VAN'S AIRCRAFT, INC.

SERVICE BULLETIN 12-09-26

Subject: Loose U-1202 Attach Bolts

SB 12-09-26 Addendum

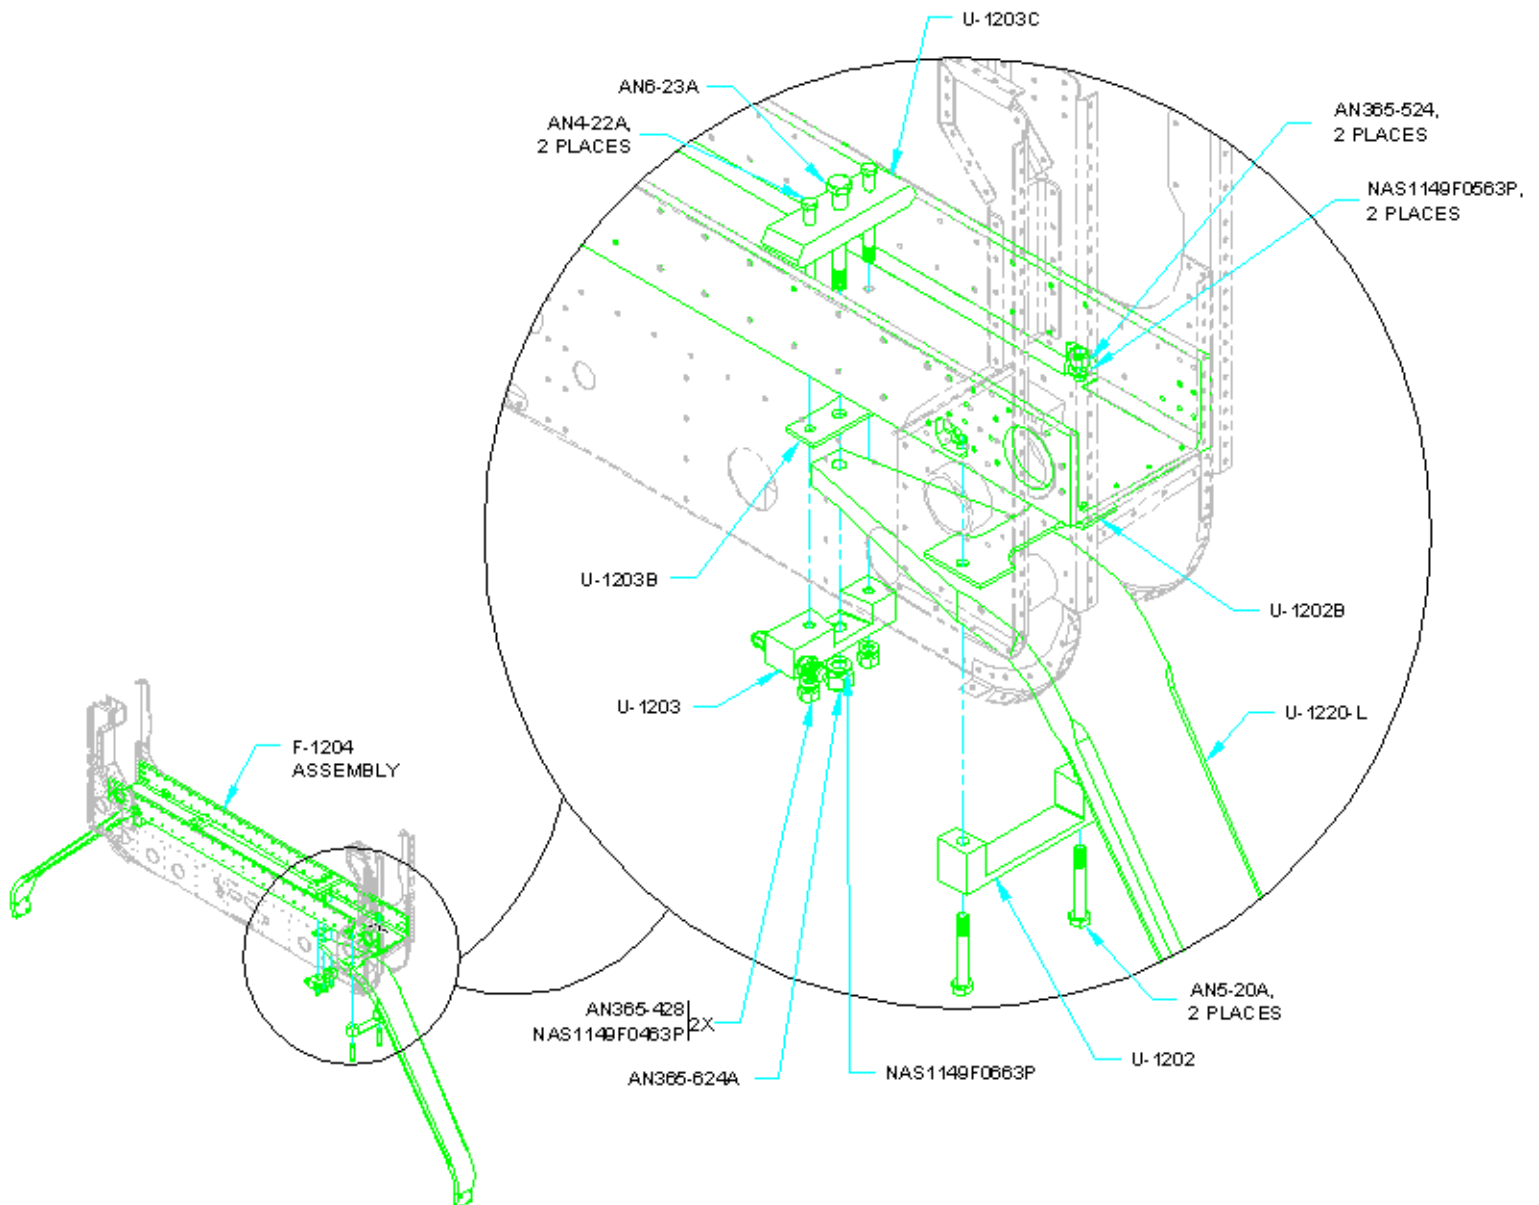
Check that the bolt is fully seated prior to torquing the nut/bolt by tapping it with a hammer (protect the bolt head with a wood block), rather than relying on the nut drawing the assembly together. Round off the lower forward corners of the U-1202 if/as required to remove any interference with rivets used for attaching the F-1225-L & -R Seat Floors to the F-1204 Center Sections Assembly. Prime areas where powder coat is removed.

FIGURE 1: DRIFT ACCESS HOLES
BOTTOM VIEW - LEFT SIDE

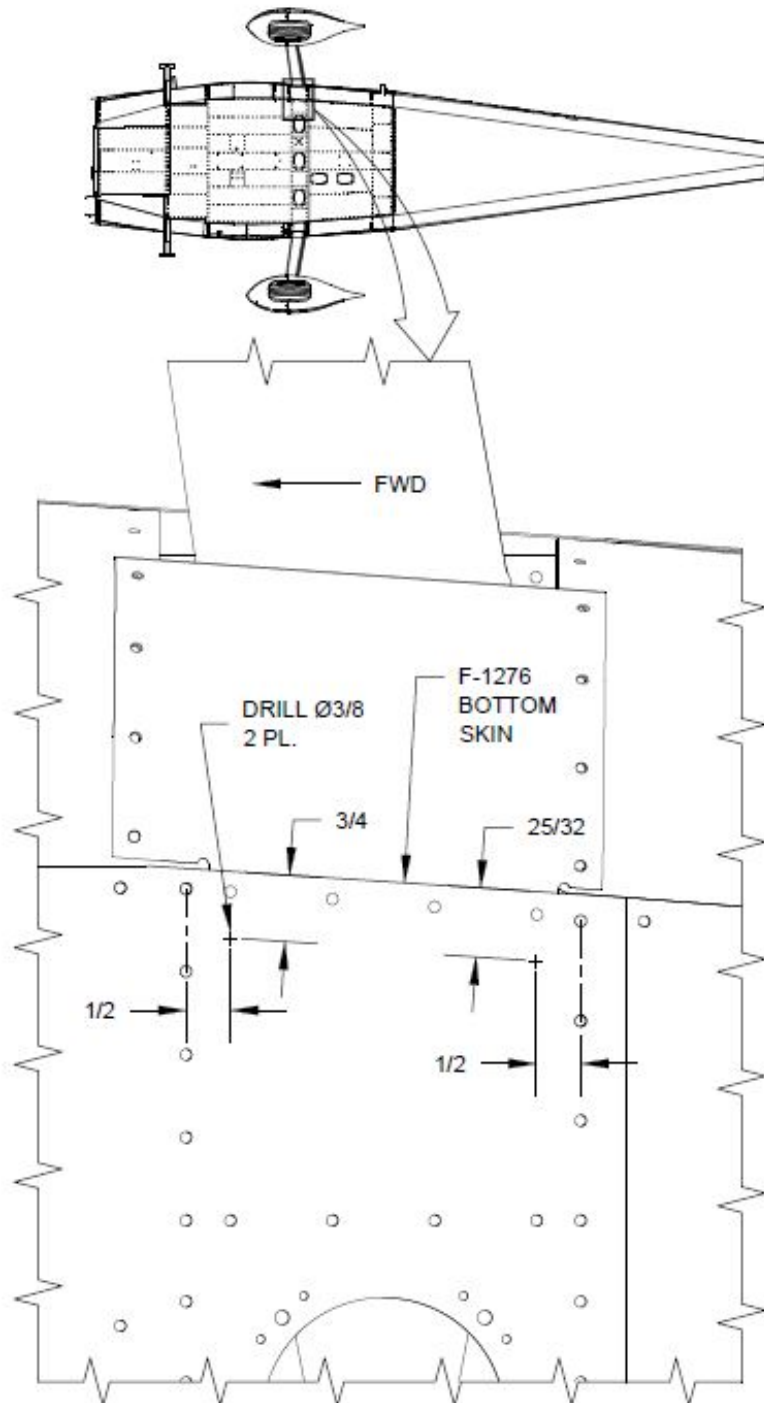
In order to properly seat a U-1202 Main Gear Attach Bracket bolt a brass drift may be used on the head of the bolt. This requires access to the head of each bolt which may be gained in one of two ways.

The first option is to drill $\frac{3}{8}$ dia. [9.5mm] holes in the F-1276 Bottom Skin to allow for insertion of the drift. See Figure 1. This still permits torque to be applied to the head of the bolt, if desired, since a socket extension may be inserted through the new hole before the socket itself is attached.

FIGURE 2: COVER PLATE INSTALLATION

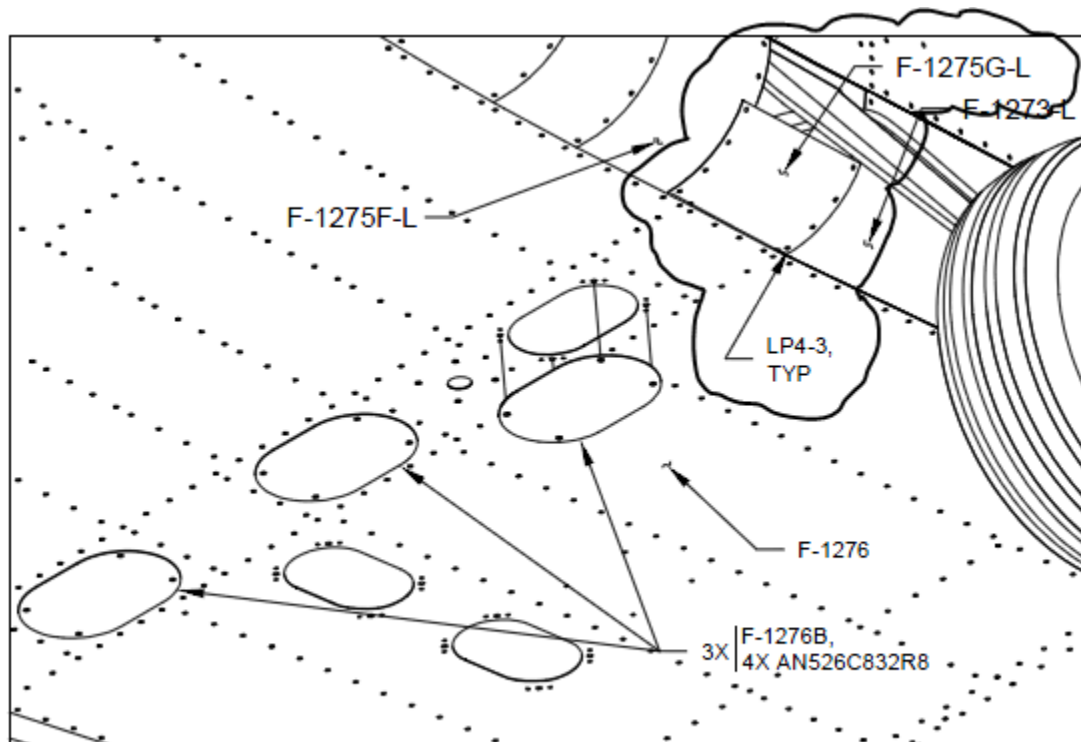
The Second option is to drill out rivets and remove the F-1275G-L and -R Cover Plates. See the following figure from drawing 35-06 Figure 2.

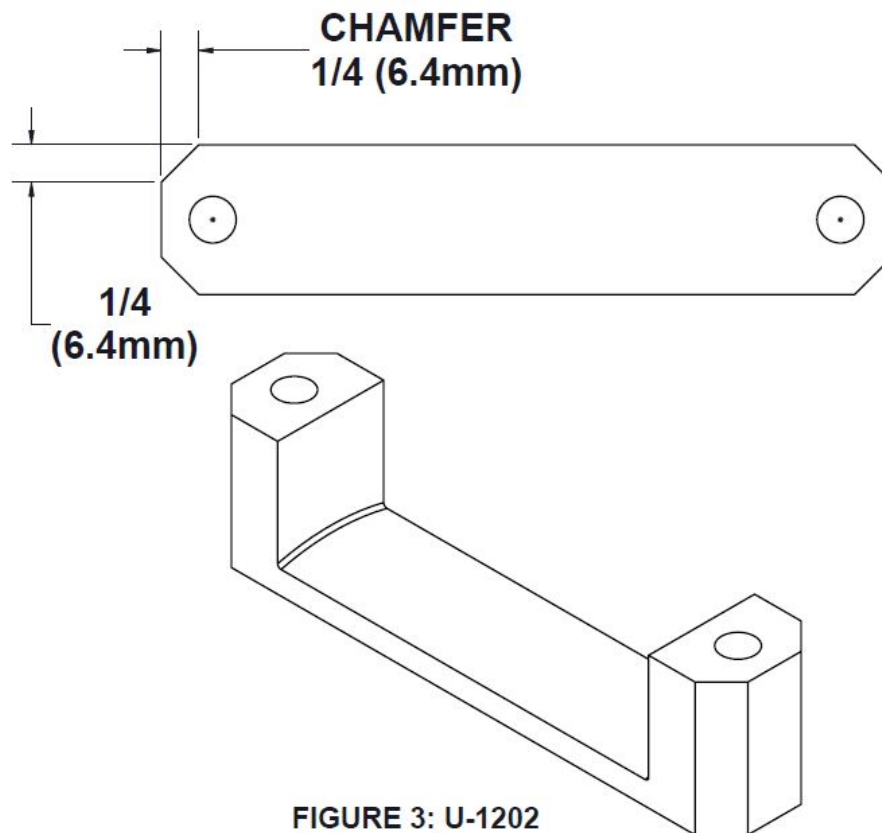
The sentence; "Round off the lower forward corners of the U-1202 if/as required to remove any interference with rivets ..." has been changed to read; "Chamfer the four corners of the U-1202 to remove interference with rivets ..."

See Figure 3 for chamfer locations and dimensions.
